PEPPERDINE UNIVERSITY

CAMPUS LIFE

Final Environmental Impact Report

March 31, 2011

View profile from Receptor Site "T" within Malibu Bluffs Recreation Area

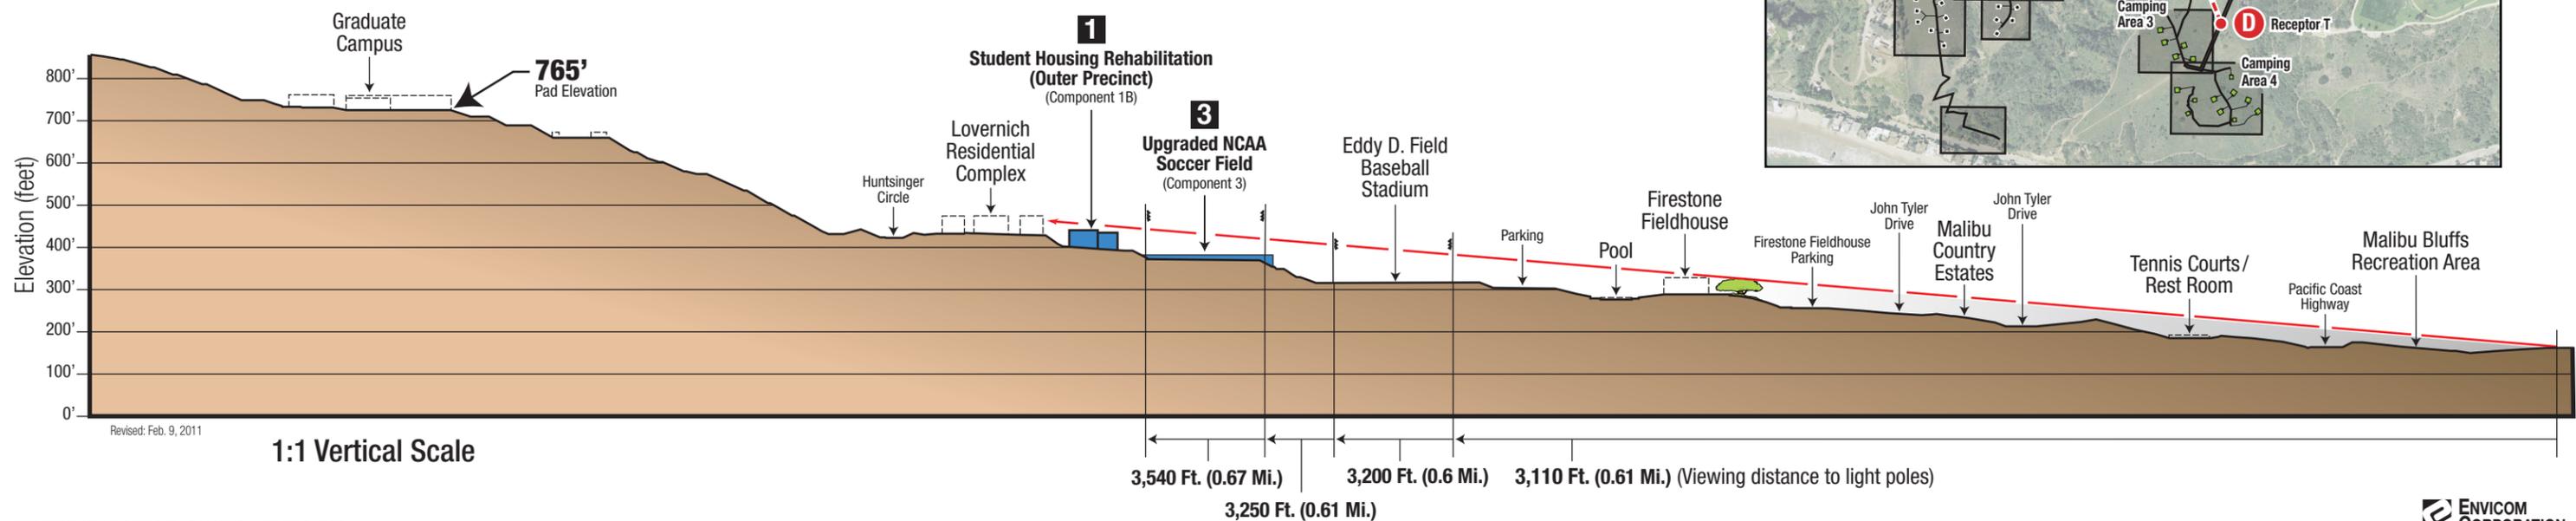
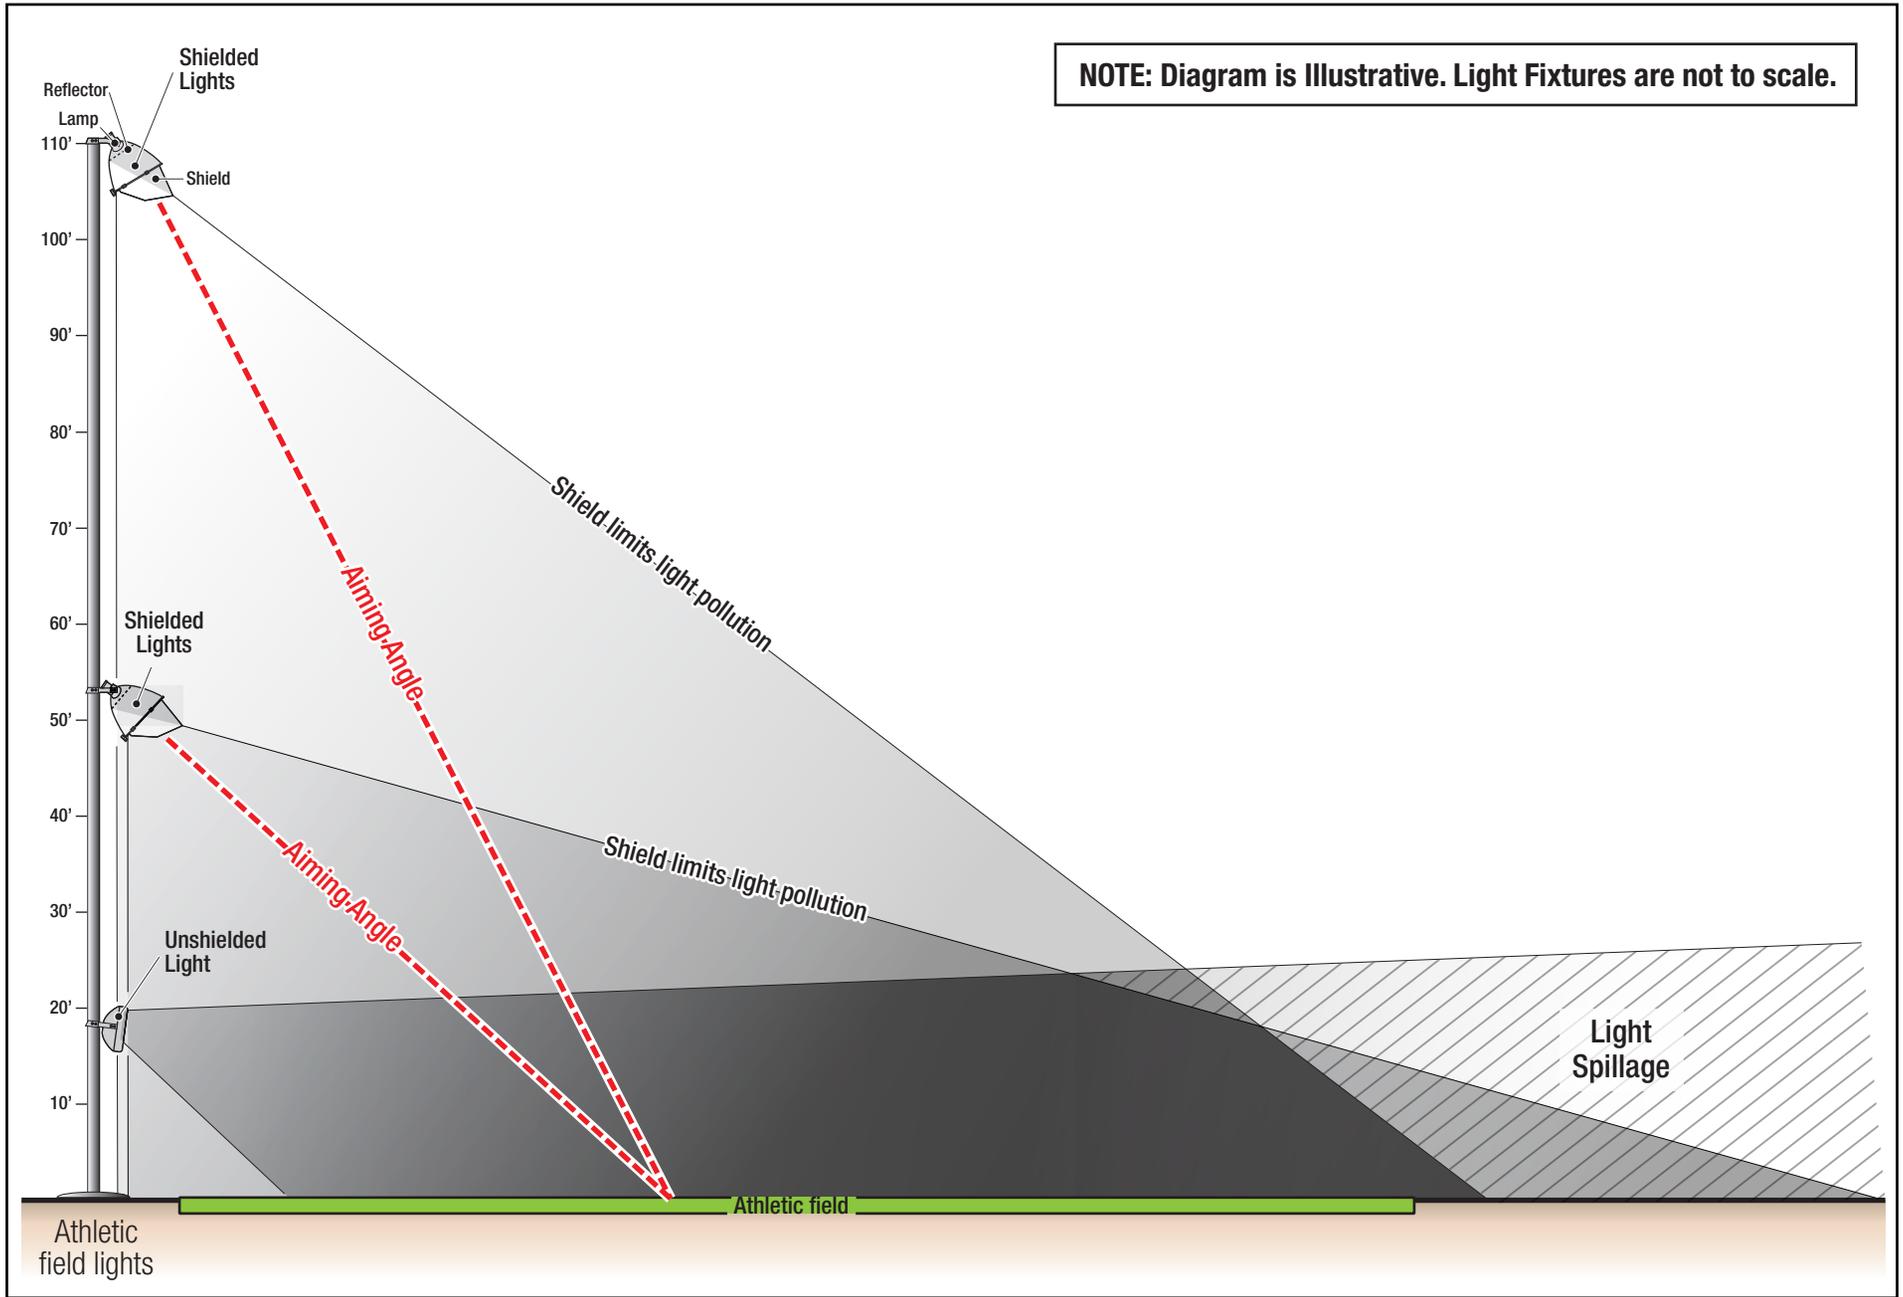
Other commenters expressed concerns that the CLP’s sports lighting would be visible from Malibu Bluffs. View study analysis has shown that the CLP Athletic lighting fixtures will be visible from Site Receptor Site T (see **Figure 1**). However, because the fixtures (or luminaires) are fully shielded and aimed downward, the light sources (lamps) will not be visible from Receptor Site T. As shown in **Figure 2**, the proposed pole heights are designed to enable steep aiming angles that reduce light trespass and glare impacts. Further, this design approach is most sensitive to concerns related to sky glow and coincides with the recommendations to reduce or mitigate sky glow provided by the International Dark Sky Association (IDA) and IESNA. Additionally, the implementation of Mitigation Measure 5.7.2-6 ensures that poles that are visible to the general public will incorporate exterior textures and color coatings that will blend with prevailing background colors and textures.

Receptor Site "T" is situated on a trail that leads from a proposed parking area to campsites in Camping Areas 3 and 4. Receptor Site "T" has a higher elevation than any of the campsites and the view from it represents the "worst-case" view of Component 3 from anywhere within the Malibu Bluffs Recreation Area.

View profile from Camping Area 2A

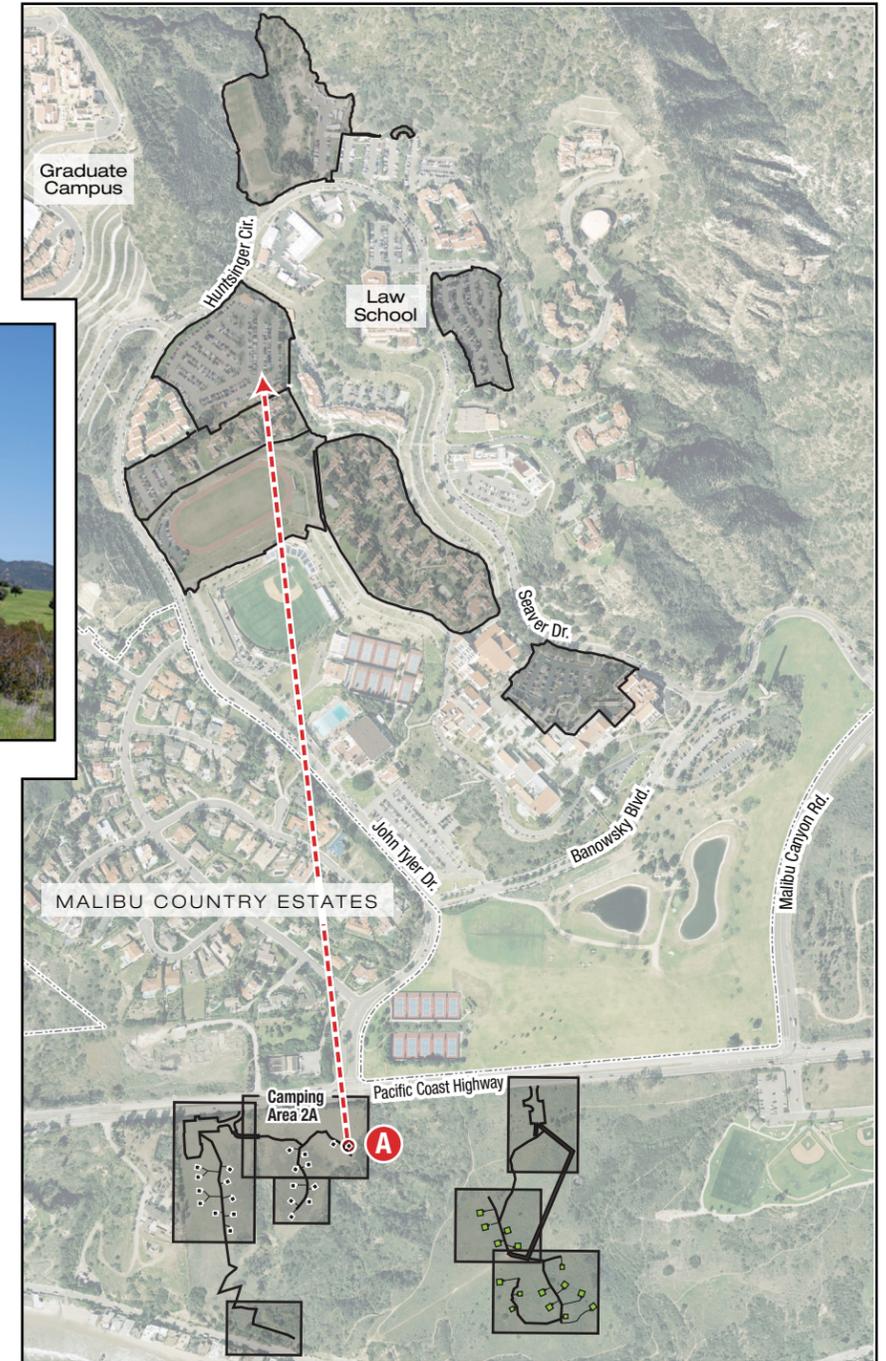
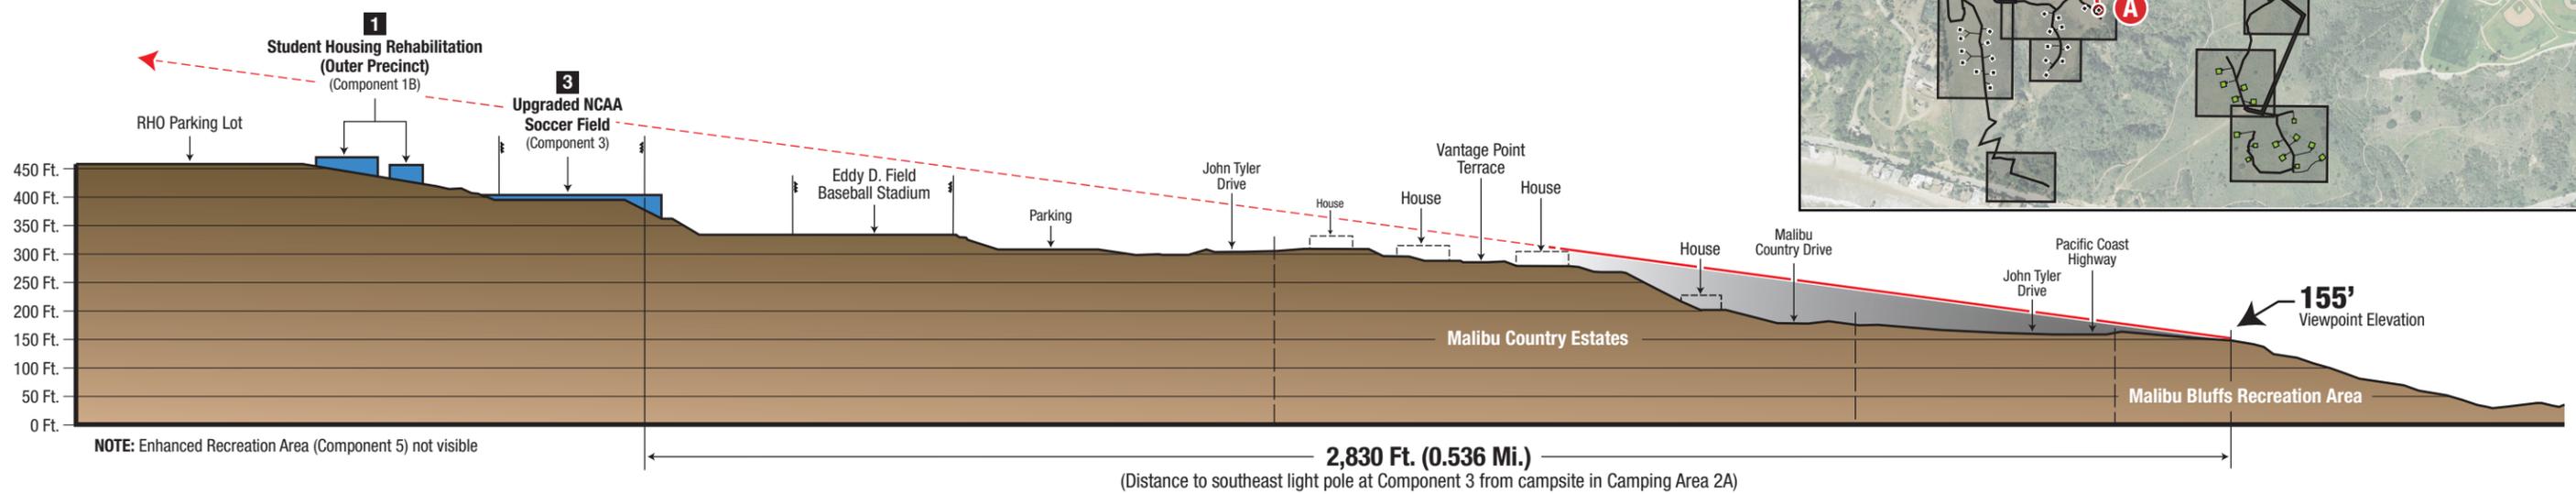
None of the light poles proposed for the Upgraded NCAA Soccer Field, Enhanced Recreation Area, and related baseball lights project would be visible from the two Camping Areas (1 and 2), located west of the John Tyler Drive/PCH intersection. This is due to the fact that the lines of sight connecting these Camping Areas to the Upgraded NCAA Soccer Field and Enhanced Recreation Area components pass over and are obstructed by the Malibu Country Estates (“MCE”) residential subdivision. The elevations and structural elements of MCE homes, topography and mature landscaping combine to reach elevations that effectively block potential views of the light poles proposed for the Upgraded NCAA Soccer Field, the Enhanced Recreation Area, and the related baseball lights project (see **Figures 4 and 5**). The obstruction of views applies to the campsites in Camping Area 2a, which are located near John Tyler Drive and PCH and have a higher potential for views of the CLP and related projects (see Figure 4, Profile A). A second terrain view profile, represents a line-of-sight cross-section from the southern-most campsite in Camping Area 1 and it illustrates the distances between the campgrounds and proposed CLP and related projects as well as the intervening obstructions that block views (see Figure 5, Profile B).

The elevation of Malibu Country Estates intervenes to block visibility of athletics and recreation areas and associated facilities in views from all campsites in Camping Area 2A.

View profile from Camping Area 1

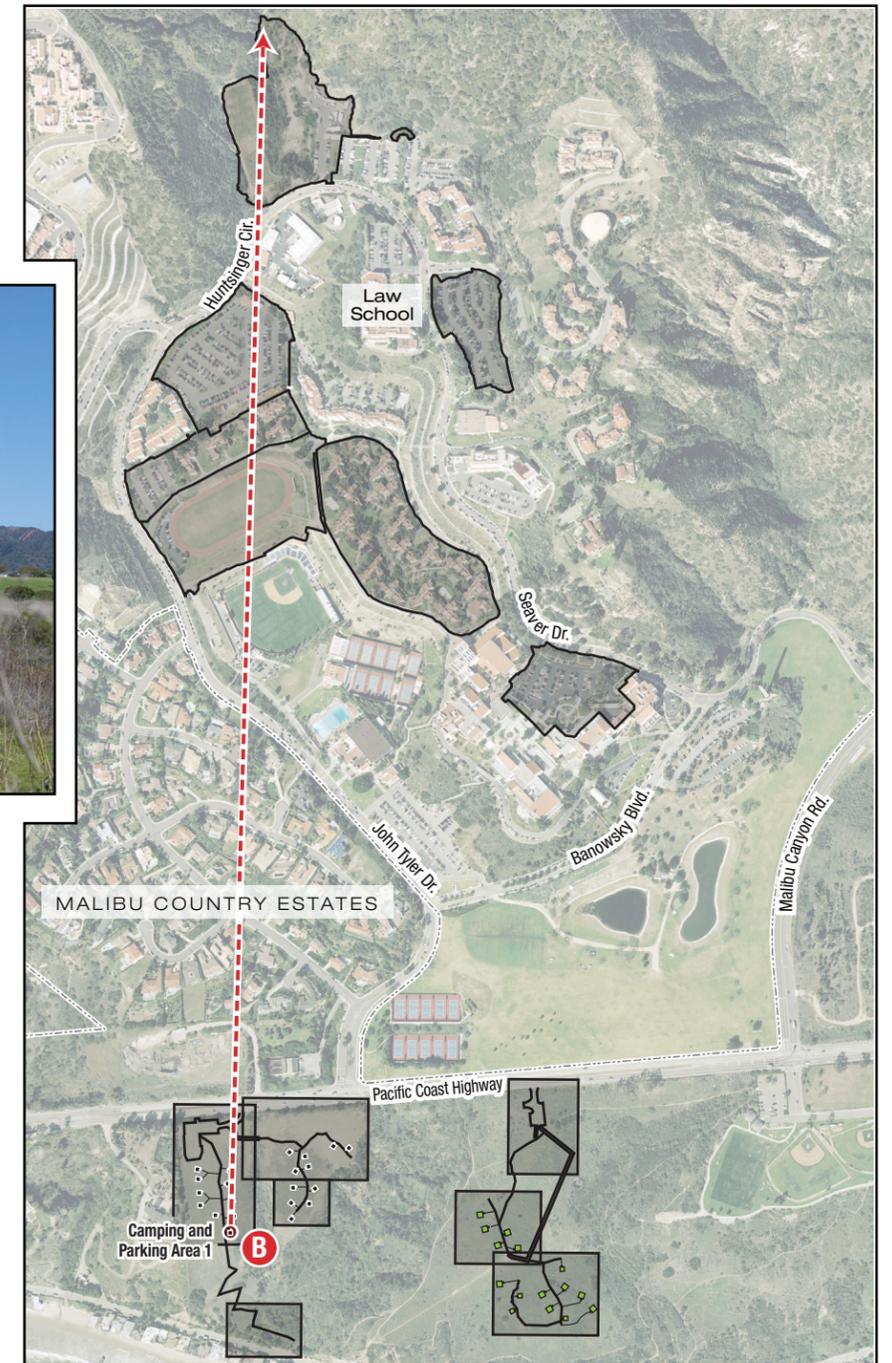
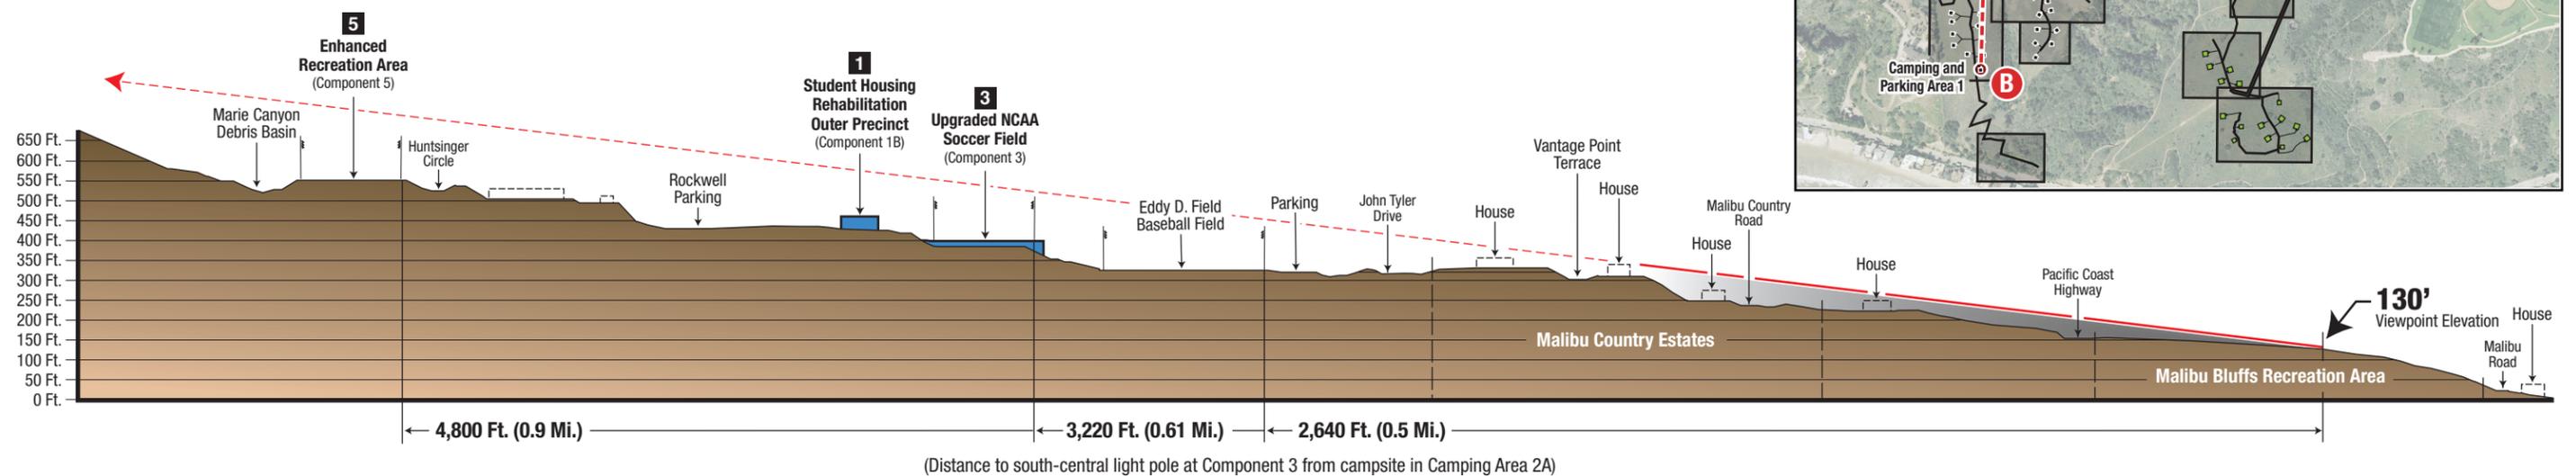
This comment is in regard to potential lighting impacts at the Bluffs. Please refer to Topical Response 2: Lighting for discussion of reasons why the Project will not result in any significant light trespass and/or glare impacts at the Bluffs. See also Topical Response 4: Athletics and Special Events for a discussion of the frequency of events held at the Upgraded NCAA Soccer Field and Athletics/Events Center, and Topical Response 7: Related Projects for a discussion of the baseball field lighting. As stated therein, after mitigation no significant cumulative significant impacts related to lighting will occur upon completion of the Project and other related projects.

The elevation of Malibu Country Estates intervenes to block visibility of all existing, and proposed athletics venues and facilities in views from campsites in Camping Area 1. In this "worst case" view from the southern-most campsite in Camping Area 1, even the water tanks overlooking the Graduate Campus are not visible.
